UPDATE MG
MICRO 12006
15532

Application Type: Right-of-Way Relinquishment and Pipeline Decommissioning
(Partial)

Subject: Response to a "Request for Clarification #3" to the Application for the Partial Decommissioning and Relinquishment and Modification of Sea Robin's 24-inch Natural Gas Right-of-Way Pipeline, Segment No. 12006, OCS-G-01907AB, Gulf of Mexico, Federal Waters, Offshore Louisiana.

Sea Robin SMI 128 24-inch Pipeline Modification (Seg. 12006)
MMS Permit Application Clarification #3 Response

SAFETY FLOW DIAGRAM

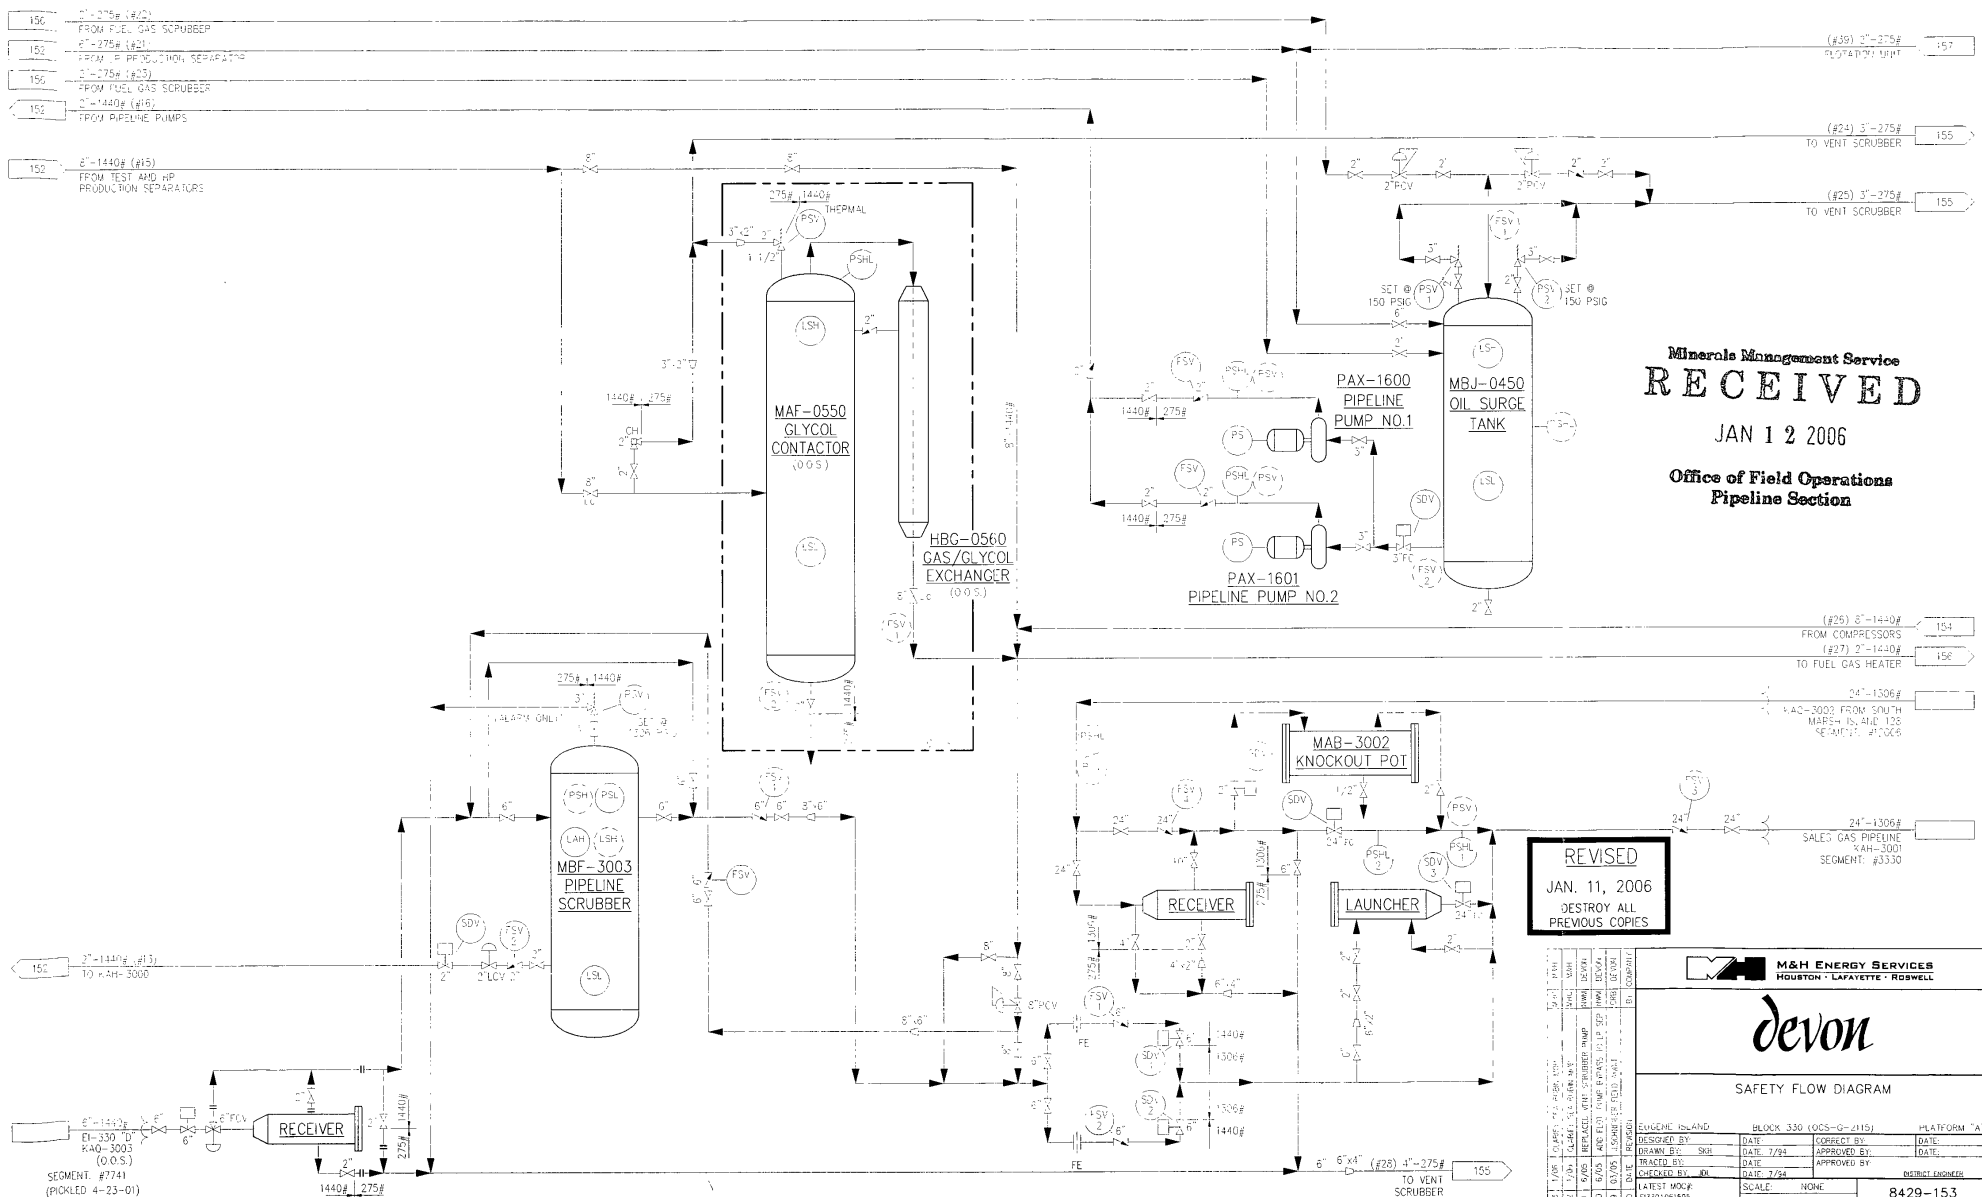
1. Segment 12006 MAOP
 - Sea Robin has elected to reduce the MAOP of Segment 12006 from 1440 PSIG to 1306 PSIG.
2. EI 330 "A" Platform Safety Schematic
 - A Safety Flow Diagram of the EI 330 "A" platform is included in the package for reference. (Reference Drawing 8429-153 Rev 23)
 - The referenced drawing has been revised to illustrate the revised MAOP of 1306 PSIG on Pipeline Segment 12006.
 - The referenced drawing has been revised to illustrate the respective pressure specification change locations on the EI 330 "A" Platform.
 -
3. "FC" Notation
 - The "FC" notation on the EI 330 "A" Platform Safety Schematic is an abbreviation for "Fail Close".

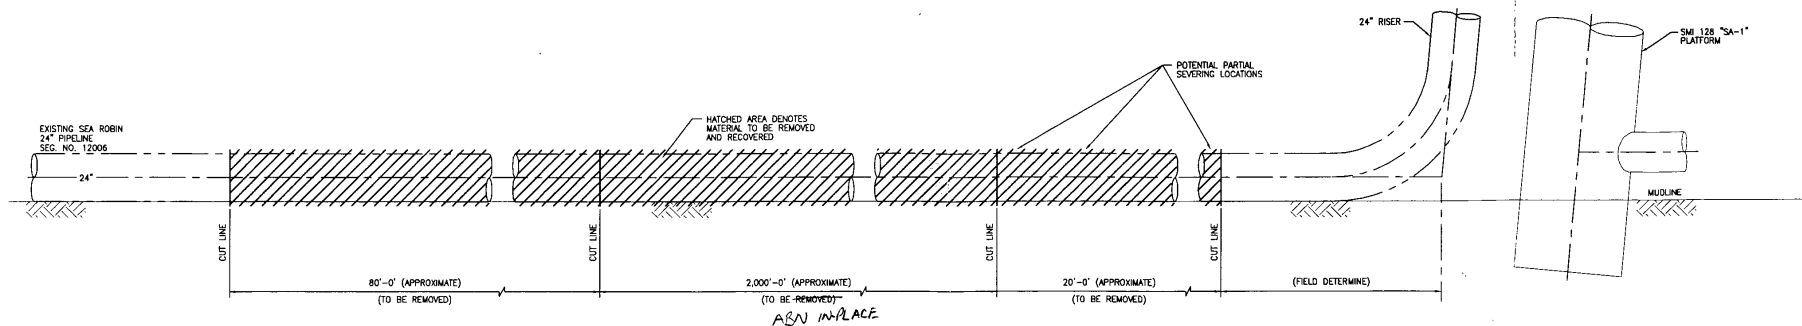
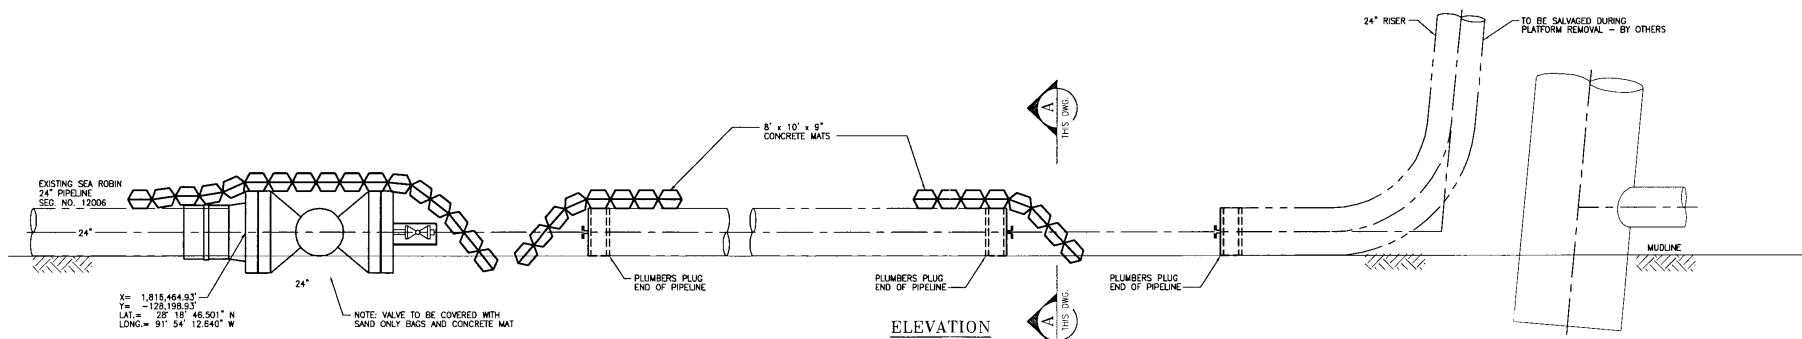
- Sea Robin plans to facilitate the flooding process by partially severing the pipeline in three (3) close proximity locations. These three (3) cut locations will be made as close as is safely possible to the damaged SMI 128 "SA-1" platform. (Reference Drawing PER-02 Rev C) Each partial severing location will be within the approximate 20 ft. segment of pipe to be removed for onshore disposal.

- Sea Robin will utilize plumber's plugs, or equivalent, when pipeline plugging operations are performed (Reference Drawing PER-02)

- Sea Robin will cover the 24-inch ANSI 900 fitting attached to the 24-inch pipeline with concrete mats. The edges of the concrete mats will be buried. (Reference Drawing PER-02)
- Sea Robin will cover each cut and plugged end of the pipeline, except the pipeline end attached to the riser which will be removed by others. The edges of the concrete mats will be buried. (Reference Drawing PER-02).
